OTRCC Parking and Transportation Committee

June 6, 2019

Meeting Notes Regarding Liberty Street Safety Project

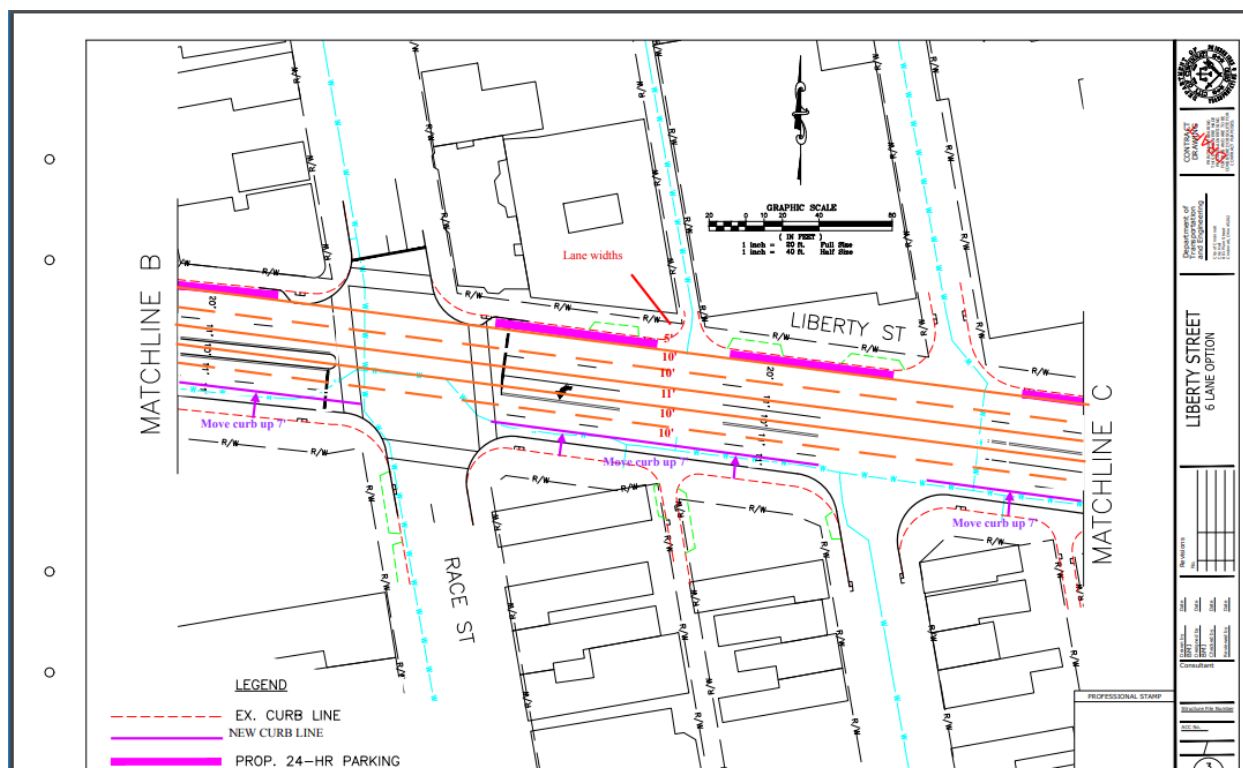
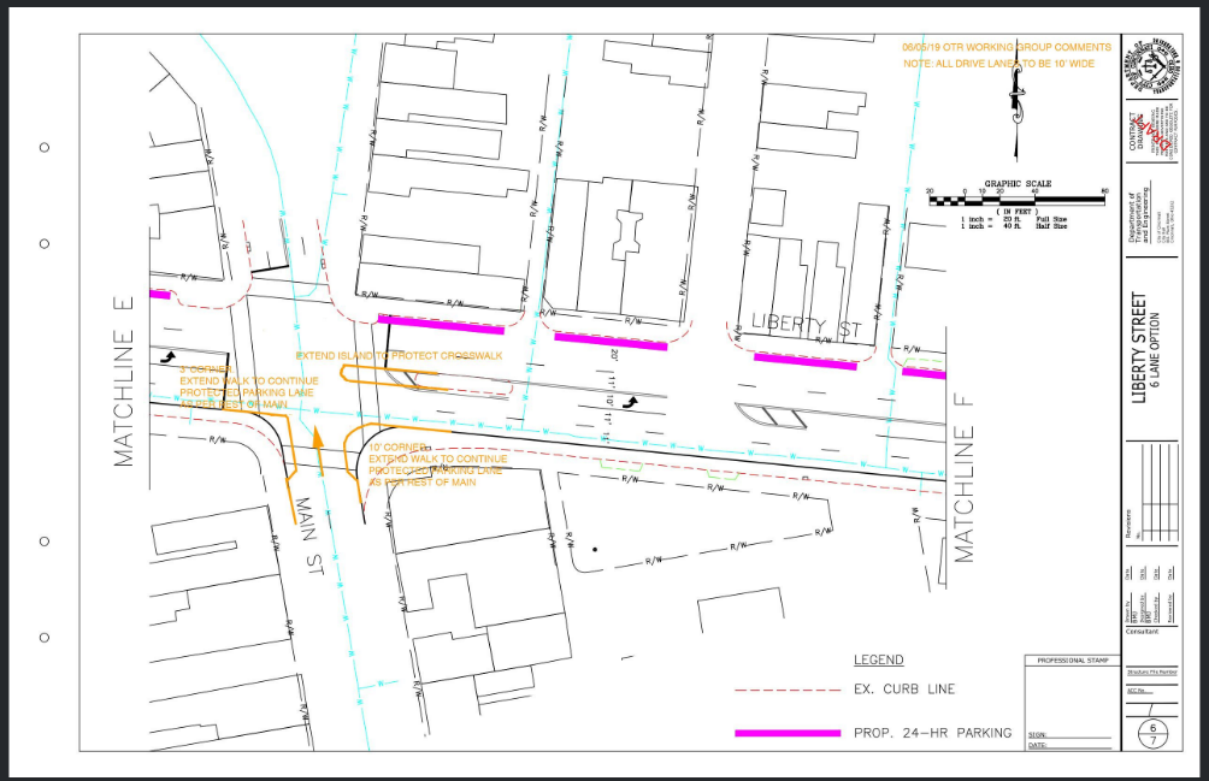
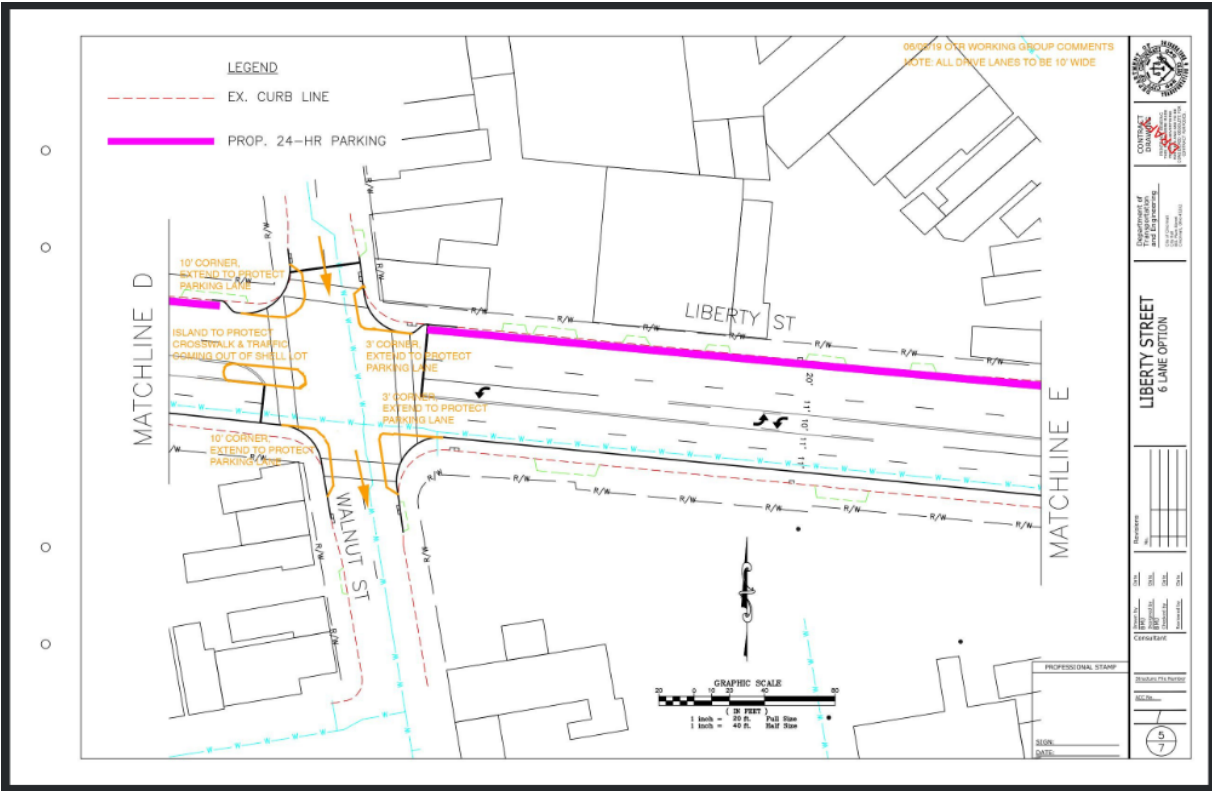
1. Ten-foot lane widths for traffic lanes through the project. Parking lanes should be smaller as feasible.
2. Review and tighten the turn-radius at curb corners. DOTE will make every effort to reduce turn radii at curb corners, especially where no turns take place at one-way streets.
 - a. While doing this, bumpouts that protect parking lanes on North/South streets should also be included whenever possible.
3. Curb cuts are to be eliminated to the extent possible and unused. No new curb cuts on the south side of Liberty.
4. Alleyway connections are to be retained, wherever possible, especially Parvis and Goose.

5. Extend the traffic islands into the crosswalks to reduce crossing distances, similar to Central Parkway, everywhere feasible.
6. Use other materials/tactics to differentiate the crosswalks. Set a maintenance schedule for upkeep of crosswalks.
7. Zebra crossings should be used throughout the project as much as possible
 - a. In light of the current initiative to increase spending on pedestrian safety, review the current city policy that only allows zebra crosswalks to be installed in NBDs (neighborhood business districts) and near schools. Concurrently, we request a review to see how many Liberty Street intersections are covered by the Vine Street and Main Street NBDs, as well how far the school zones extend around Rothenberg, St. Francis Seraph and other charter schools.
